REGIONAL REVIEW FINDING

ARC REVIEW CODE: R905211

Submitting Local Government: City of Conyers
Name of Proposal: Corner Market Development

GRTA Site Plan DRI No. 1970

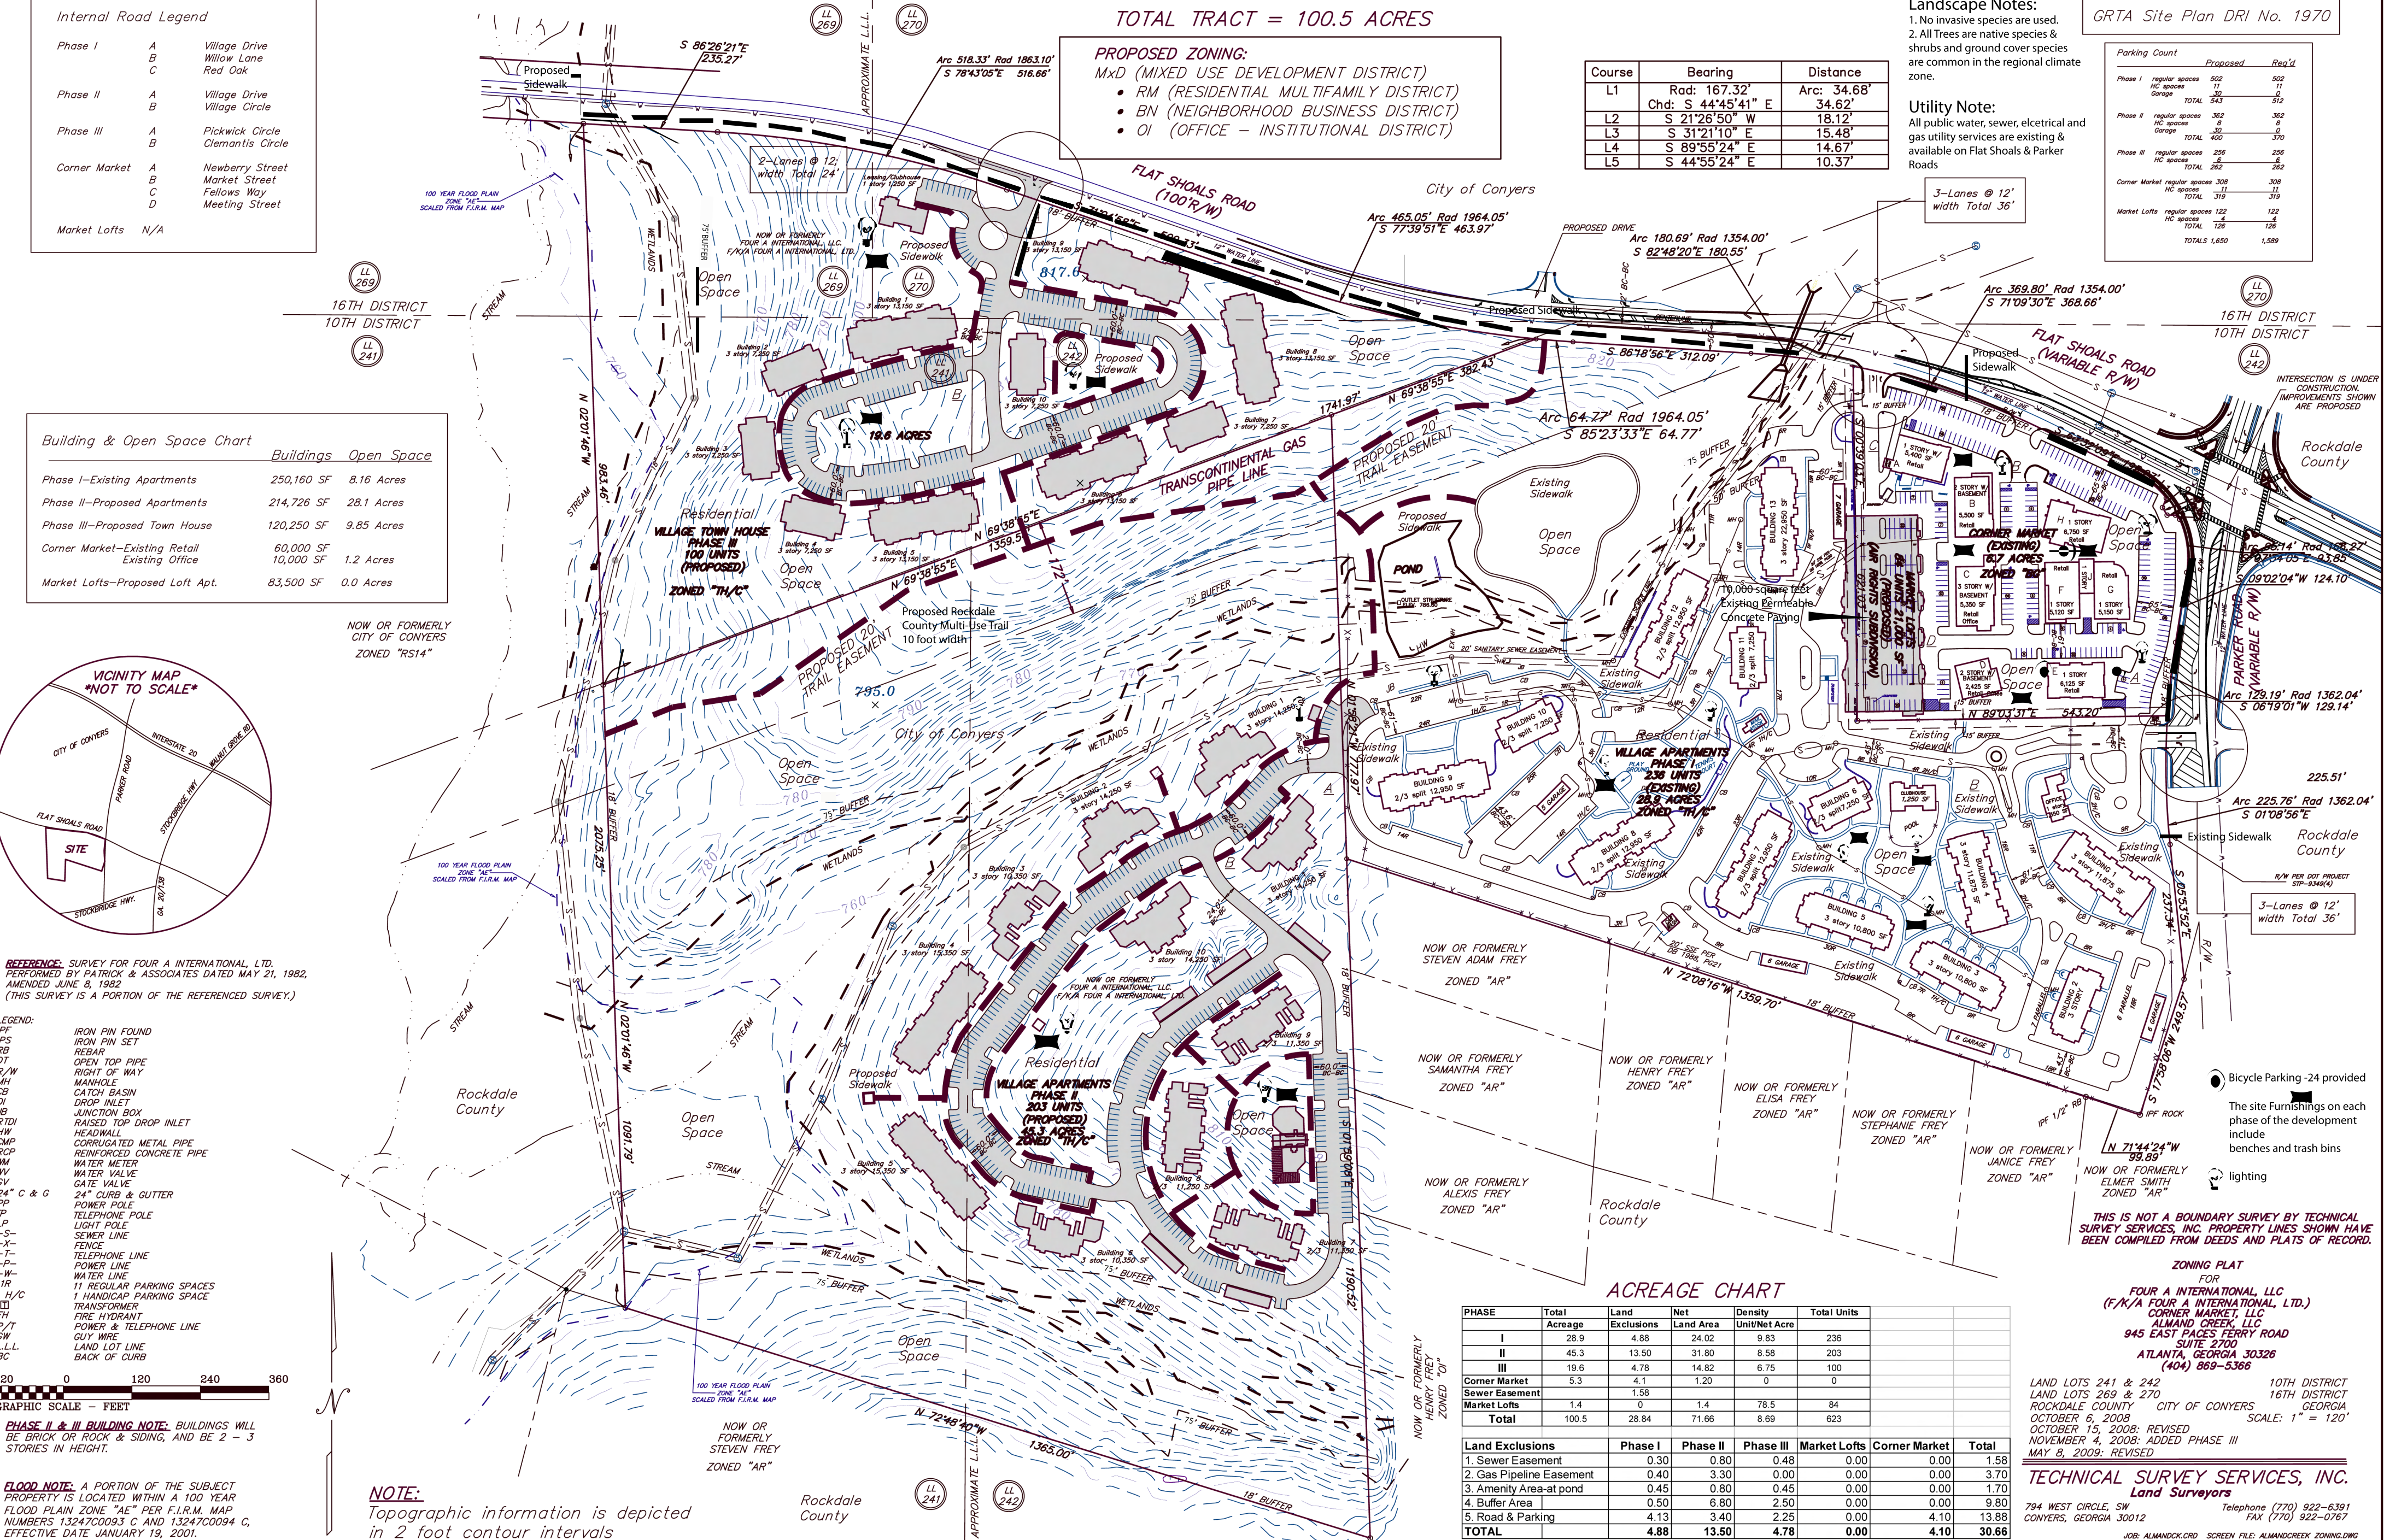
ARC would like to see better connectivity within the site between the townhouses in phase III and the rest of the development. This could be accomplished by adding a drive between the two sections and/or creating more direct bicycle and pedestrian access.

ARC strongly recommends that more pedestrian amenities, such as pedestrian lighting, street trees, benches, etc. be provided along the public sidewalks as well as the multi-use trail to enhance the pedestrian realm as well as increase the likelihood that residents and visitors to the area will use the facilities

GRTA Criteria	ARC Score	Comments
B. Project			
H. Does the development contribute to public streetscapes with pedestrian-friendly amenities, such as benches, lighting, street trees, trash cans, pedestrian entrance on street level, and windows at street level? • 3 points: Yes.		0	While the site plan shows pedestrian amenities and lights within the site, none are indicated on the public sidewalks or the multiuse trail.

The property is in the South River watershed, which is not a water supply watershed in the Atlanta Region. The project site plan shows two unnamed tributaries of Almand Creek crossing the project property. The plans show 50-foot buffers in the areas of new construction but no additional 25-foot impervious setbacks are shown, which are also required under the City of Conyers Riparian Buffer Protection Ordinance. Any intrusions into the buffer or setback that are not allowed under the City ordinance will require variances as provided in the ordinance.

- Phase 3 of the development is within the limits of project 752380 which is currently under construction. Please work with Shannon Hebb of Rockdale County to insure site plan is consistent with the design of the roadway project.
- Funding sources for the intersections needs to be identified. GDOT does not have the funds to mitigate the three intersections that are on the state route system that are shown as needing improvements in the no-build scenario.
- Left turn lanes are recommended at all proposed site driveways where left turns into the site are to be allowed in the event that traffic does meet the threshold. Safety and operations of the network should benefit from the separate left turns.

The Applicant has confirmed with the City of Conyers Planning Department that the Rockdale County Master Plan (Phases A-D) requires all multi-use trails be at least 10-feet wide; thus, the multi-use trail depicted on the Site Plan will be 10-feet wide in accordance with the county master plan.

The Site Plan for the intersection of Flat Shoals/Parker Roads (the only intersection adjacent to the Project) includes crosswalks and median refuges, which graphic was provided to the Applicant by the Rockdale County DOT. Further, current intersection improvements underway by Rockdale County DOT are being constructed in accordance with governing local requirements for streets and roads, including minimum curbing height and design.
